Honeywell Security Sensor CoE

Subject: Class II Permissive change for FCC ID: 2ABC8-PP300850SE, Original Grant date: 02/11/2014

Some Component and Layout changed.

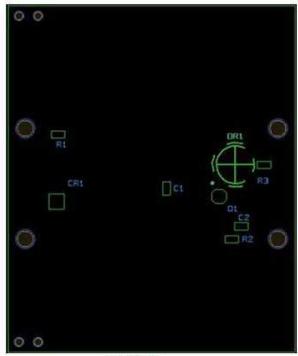
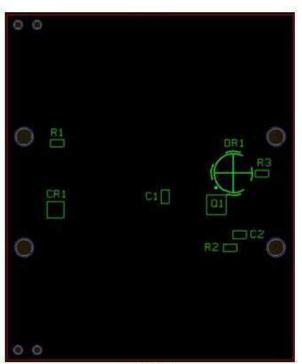
The FET electrical characteristics are quite closed, yet there are some difference in component shape and dimension.

detail change list as refer as below, Confirmed RF circuit and performance are no changed.:

- 1. Replace NE4210S01(300-06289) with CE3512K2(300-09313)
- 2. Replace DR(300-06688) with DR(300-08959)
- 3.Replace Resistor 21ohm(5-108-2212-00) with 33ohm(RJ6-3301)
- 4.PCB minor changed (replace PCB footprint of NE4210S01 with CE3512K2')

200-01027 200-01867

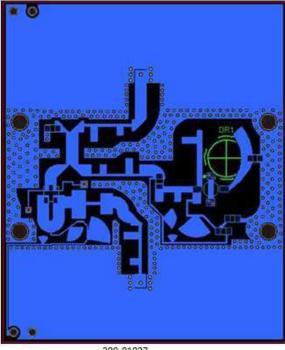
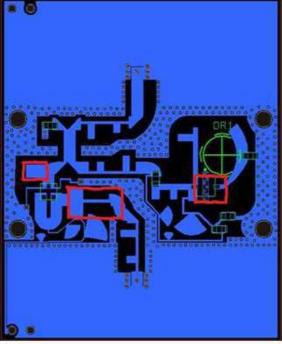
• PCB layout change in back layer block in RED Difference of PCB layout
